# Summary of Comments and U.S. Fish and Wildlife Service Response

Notice of Availability and Request for Comments:  
Draft Environmental Assessment and Draft Oil and Gas Industry  
Conservation Plan for the  
American Burying Beetle in Oklahoma

79 FR 21480

May 21, 2014

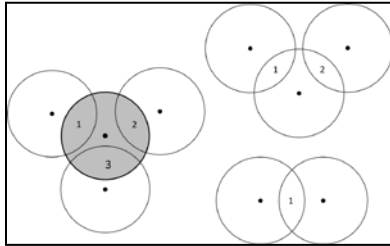
*ICP Comment 3 (Hall & Howard):* American Burying Beetle Conservation Priority Areas; "...only buffers that intersected three or more other buffers were included as a CPA." Does this mean that clusters of four (4) or more 10K buffers were used or three (3) or more? It is unclear.

*Service Response to ICP Comment 3:* CPAs include all buffers that intersected at least 3 other buffers. In the example figure below, only the shaded buffer circle would have been selected as part of the CPA.
